CASE NUMBER: PZ 25-008

APPLICANT: Traton Homes; Represented by Kevin Moore.

VARIANCE REQUEST: To allow development in the Special flood hazard area, future conditions flood hazard area, adjacent flood hazard area. Flood Protection Variance.
Variance Request to UDC Section 10-11

LOCATION: 5525, 5535 and 5500 Elliott Road, within land lots within land lots 659 660 673 674, 2nd section, Cobb County Georgia.

Figure 3. Floodplain proposed development.

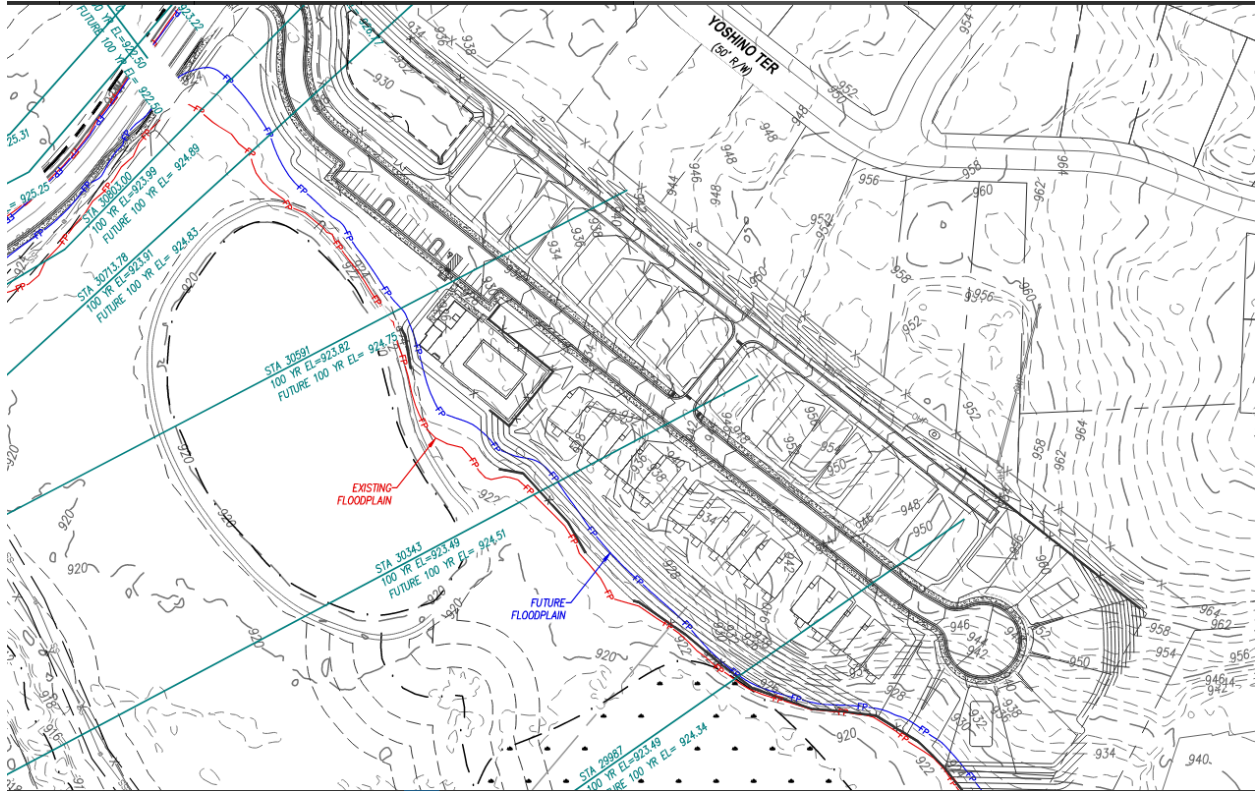
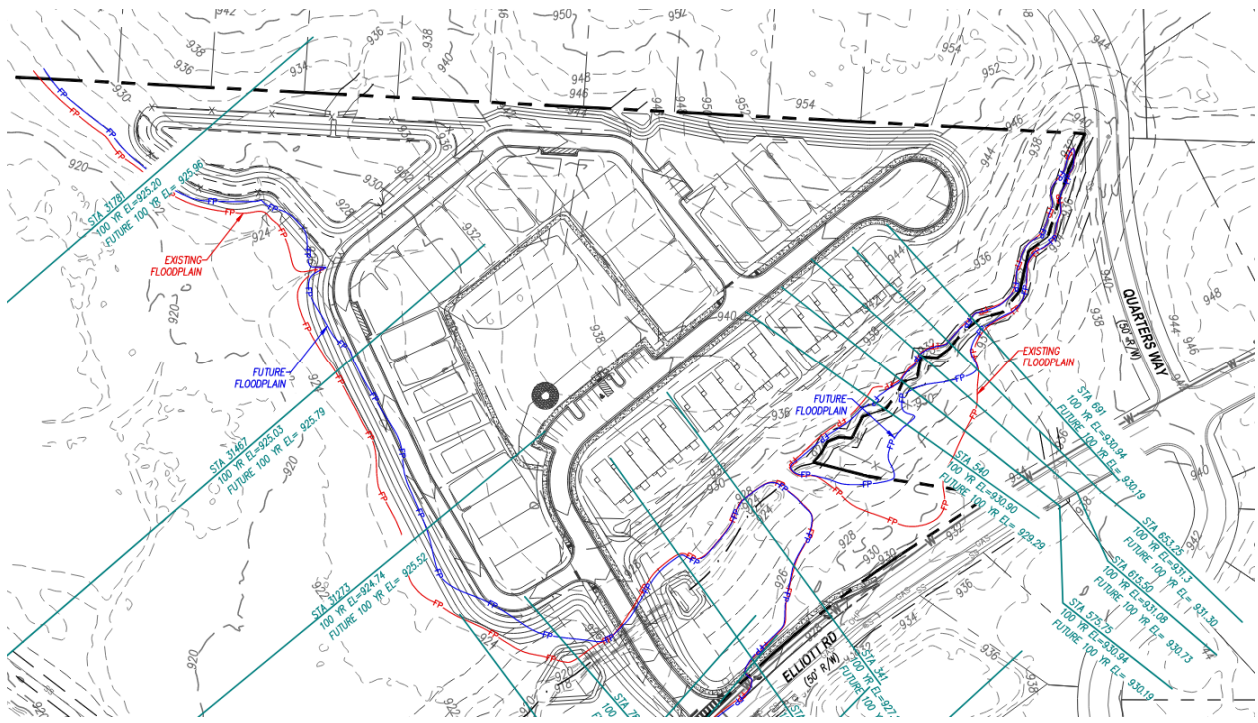
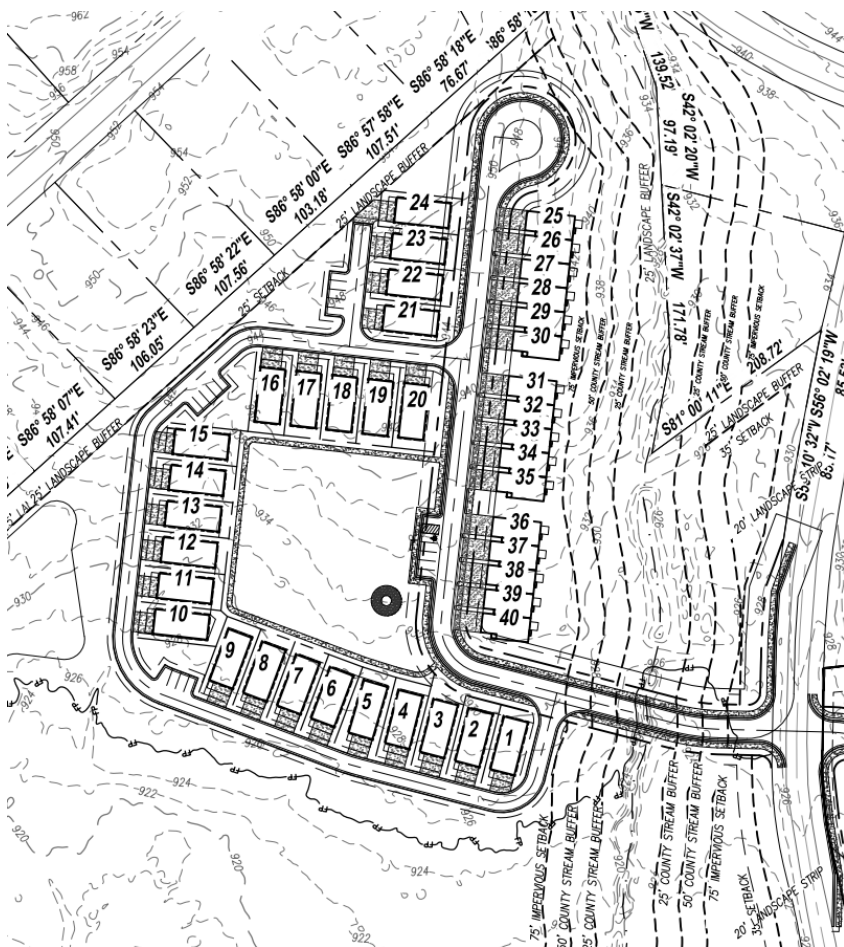
The applicant is proposing a development where all residential units and paving will be located outside of the regulatory areas, however some site work is required to develop the site as shown in the approved site plan.

No structures will be located in the floodplain, only grading.

The No-Rise reports and supporting engineering study prepared in support of Elliott Green North and South proposed development have been reviewed and comments on the compliance with the City's Floodplain Management requirements were made dated 03/12/2025 and 05/06/2025. These comments have not been addressed. It is recommended that this floodplain variance is conditional upon the developer providing during the LDP permit stage, a certified No-Rise report and the supporting engineering study prepared in accordance with the following requirements:

- City's Article 10 Sec 10-15 - Engineering Study requirements are met
- City's Article 10 Sec 10-16 - General standards for encroachment are met

1. During the LDP permit review, the developer provide a certified No-Rise report and the supporting engineering study prepared in accordance with the following requirements:
 - Article 10 Sec 10-15 - Engineering Study requirements are met
 - Article 10 Sec 10-16 - General standards for encroachment are met
2. During the LDP permit review, the developer provide a certified engineering study and report that any proposed increases in the peak flow discharges along Powder Springs Creek are not going to increase the Base Flood Elevations, Floodway Elevations or 100-yr Future Conditions Flood Elevations along the stream.
3. After the completion of the development, As-Built Floodplain Study report be submitted to document that the development is completed as proposed, and the City's Floodplain Managements requirements have been met.
